Work Order ID 155018

Item ID: D119-646-141 Accept ***N900040100*** Setup Start ***NS1***
Revision ID: URF 15-560 Stop ***NS2***
Item Name: AW119 Replacement Skidtube with Standard Wearplates & Wearpads, Fits LH & RH
Start Date: 2/6/2017 Start Qty: 1.00 ***1*** Cust Item ID:
Required Date: 2/13/2017 Req'd Qty: 1.00 ***1*** Customer:
Reference:

DRAWING NO. D3887	TITLE A119 STD SKIDTUBE ASSY	REV. D	DART AEROSPACE USA, INC. ENGINEERING ORDER		D.E.O. NO. D3887-D-1	SHEET NO. SHEET 1 OF 3	SCALE NTS
DRAWN AJS		CHECKED		MFG. APPR.	APPROVED	DE APPR.	
DATE 16.11.08		DATE		DATE	DATE	DATE

SHEET 2: (1) ADD DETAIL H
(2) UPDATE PLUGGING FASTENERS AS SHOWN:

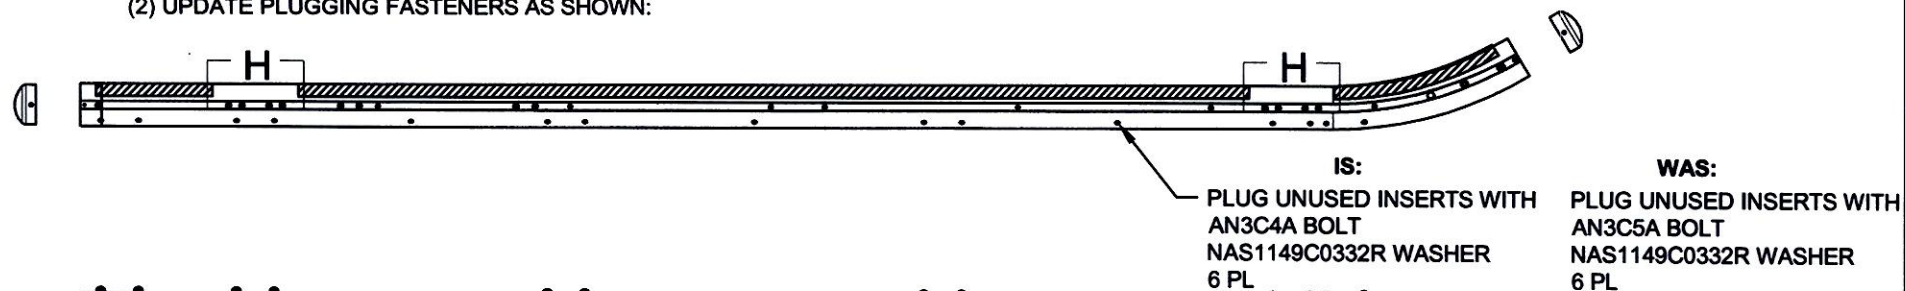
D3887-041 STANDARD SKIDTUBE ASSY WITH WEARPAD
(MAKE FROM D3887-11)

SHEETS 3 AND 4 ADD DETAIL H

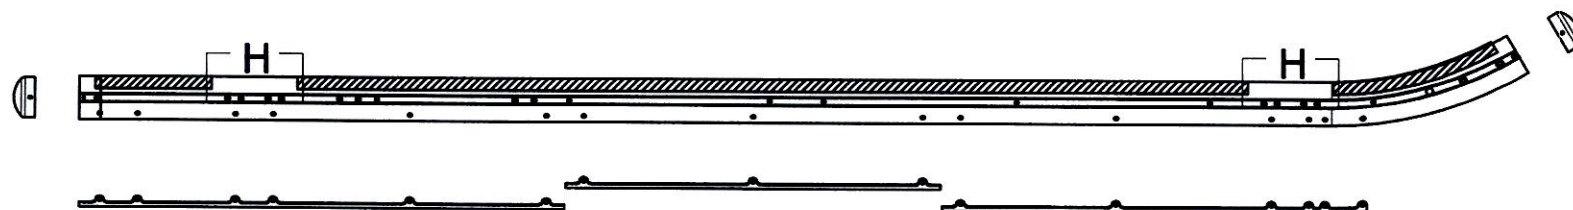
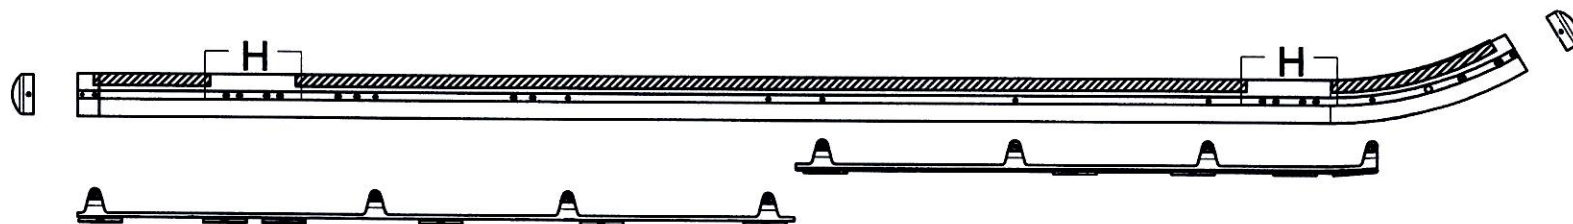
D3887-043 STANDARD SKIDTUBE ASSY WITH WEARPLATE
(MAKE FROM D3887-11)

D3887-045 STANDARD SKIDTUBE ASSY WITH TRAINING WEARPLATE
(MAKE FROM D3887-11)

SHEET 7 ADD DETAIL H TO THE FACE OF DRAWING AS SHOWN:

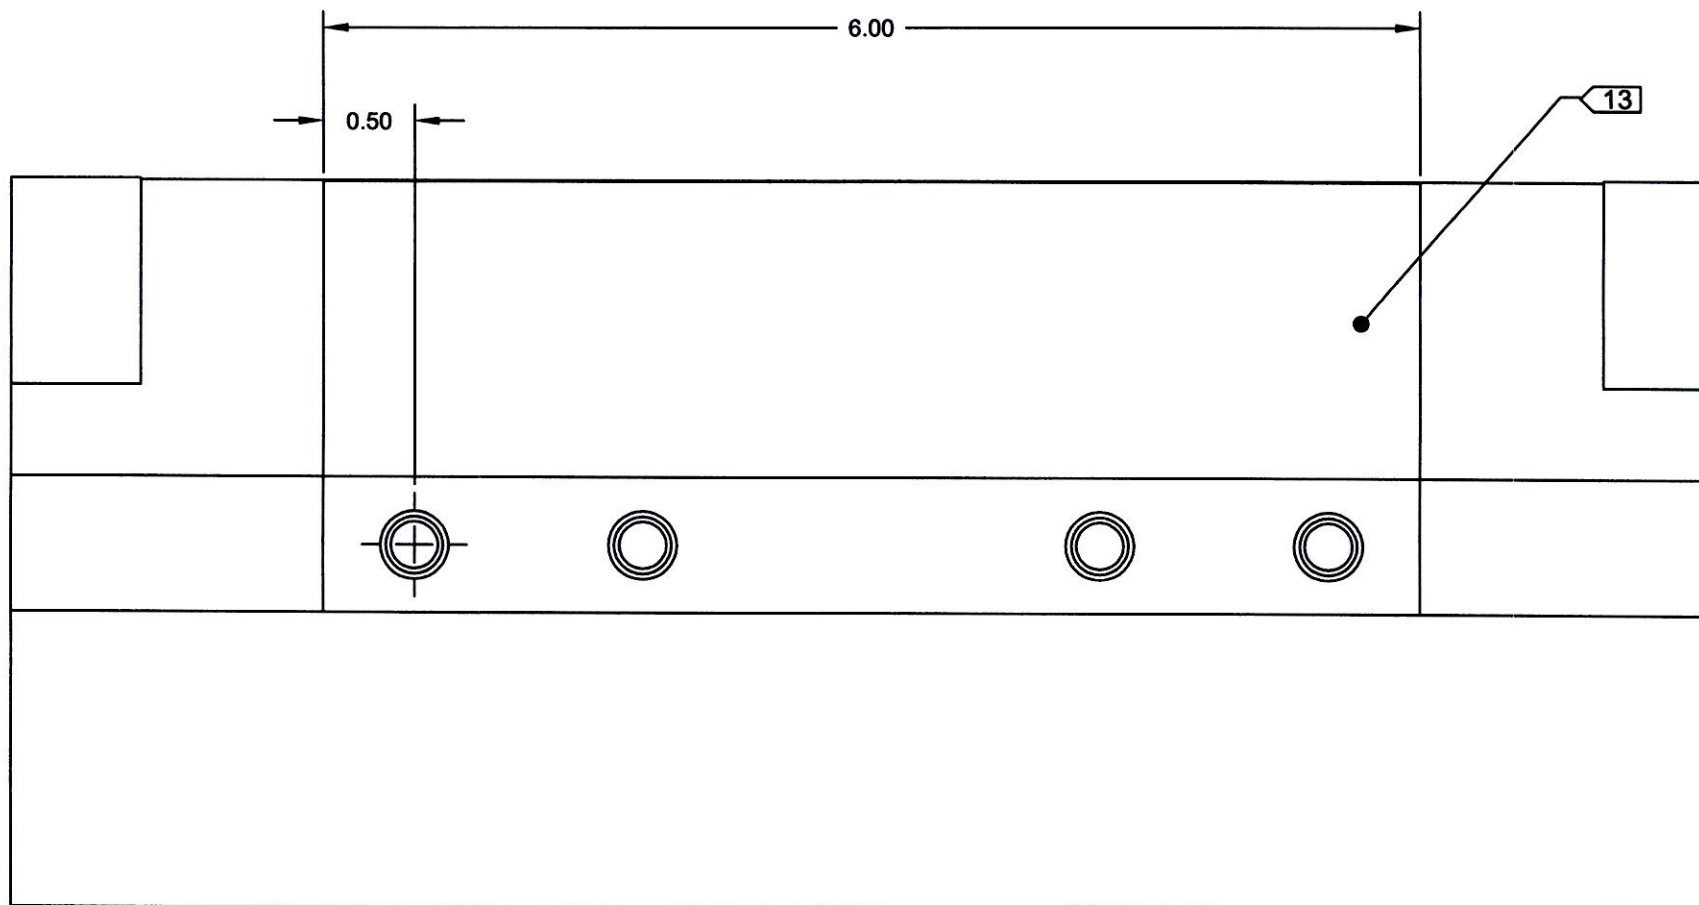
DETAIL H
